# ADDENDUM NO. 3

**January 18, 2024**

# CHESTERTON HIGH SCHOOL STADIUM IMPROVEMENTS Chesterton, IN 46304

**Addendum Three (AD.03)** to the drawings and specifications prepared by Gibraltar Design for **Duneland Chesterton HS Stadium Improvements** for Duneland School Corporation, Chesterton, Indiana.

A-101

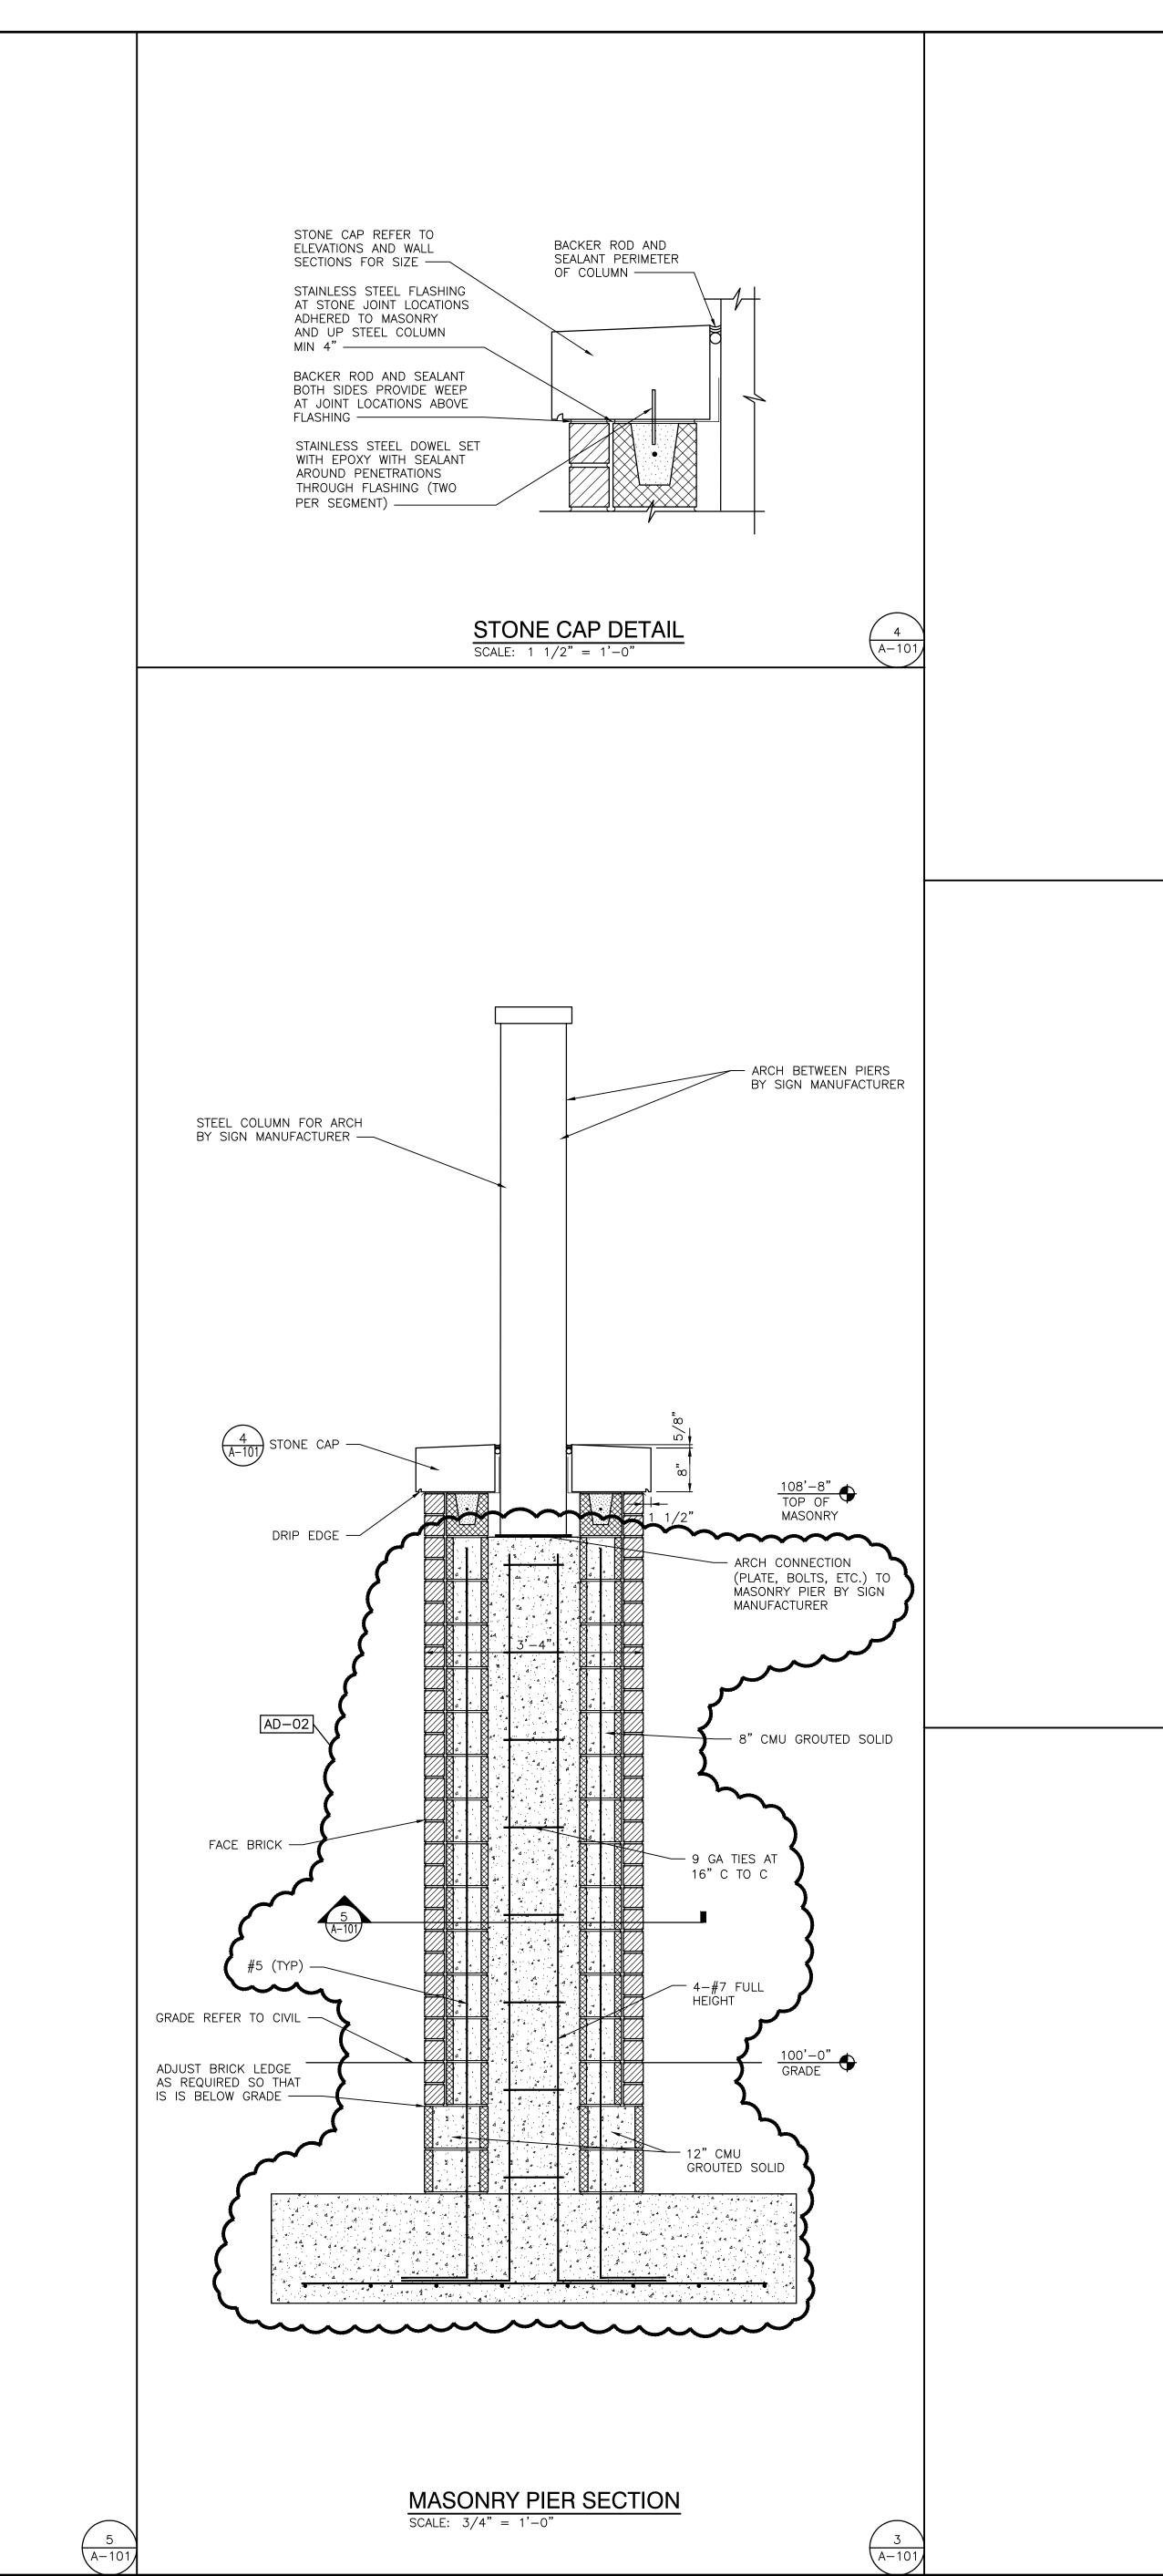
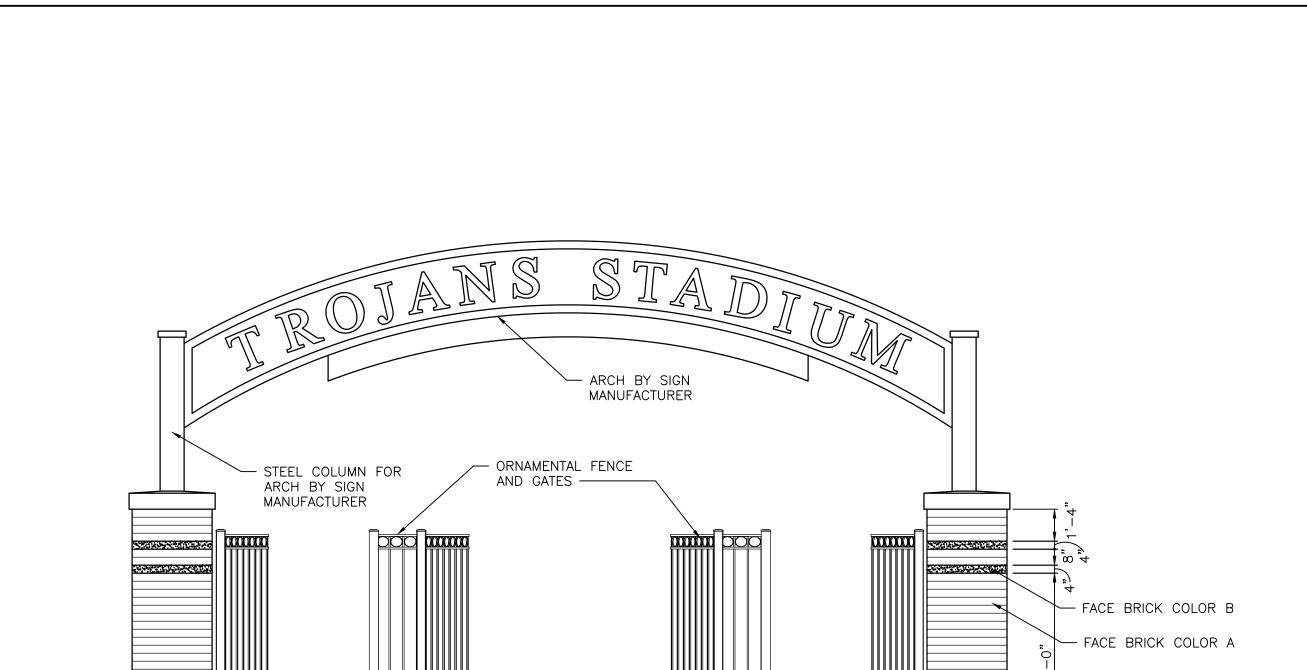
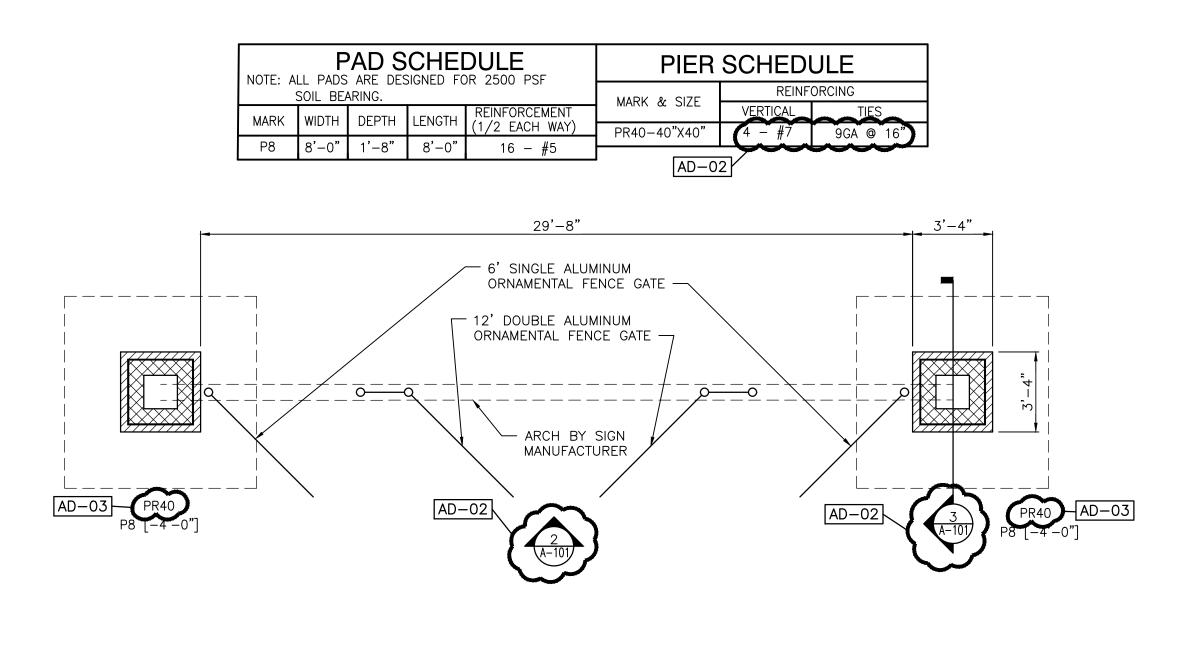
- A. Refer to revised full size drawing included in this Addendum for the following revisions.
  - 1. Remove [-1'-0"] note next PR40 under each masonry pier.
